5R55N.DRU03

Coast Clutch Drum

Part No. 5R55N.DRU03

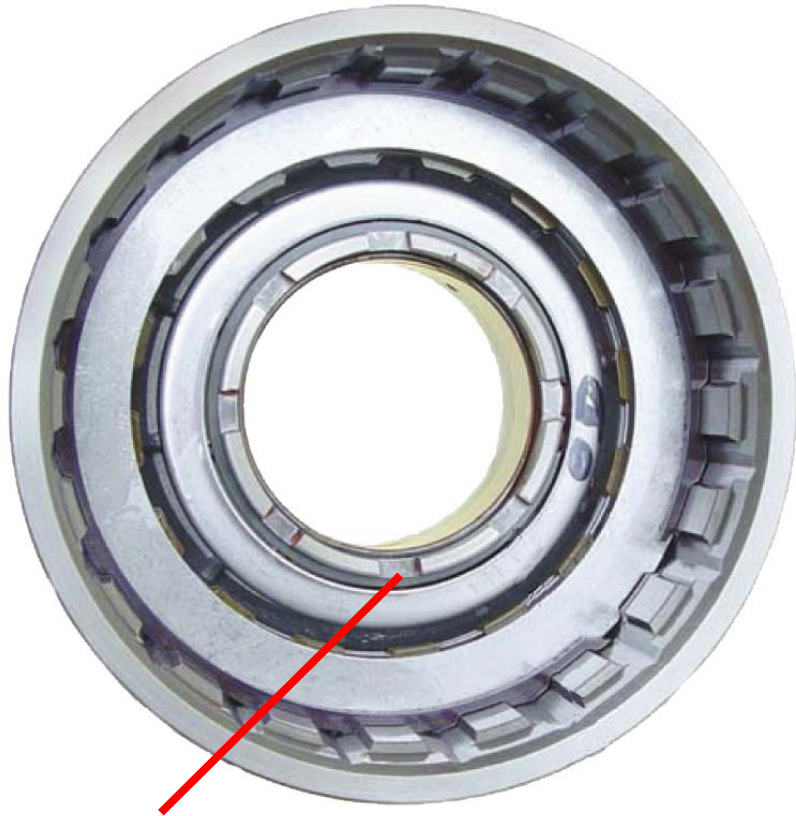
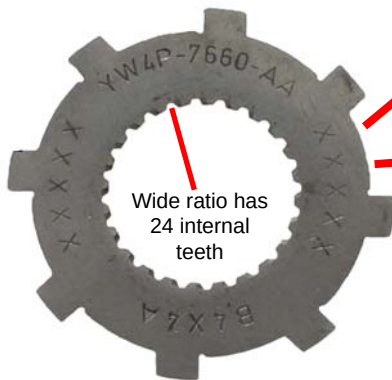
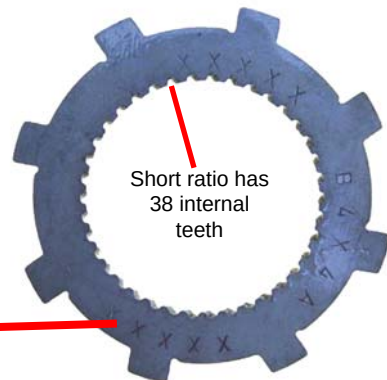
This drum is no longer available with straight slots, when replacing this drum on early units it will be necessary to use the later drum.

1999-2001 5R55N: Tabs on the sun gear Star Washer and slots in drum are straight.
2002-Up 5R55N: Tabs on the sun gear Star Washer and slots in drum are angled.
All 5R55W & 5R55S have angled tabs and slots.

and to replace the original straight tabbed Star Washer with an angled tab type

Part no. 5R55N.THW01
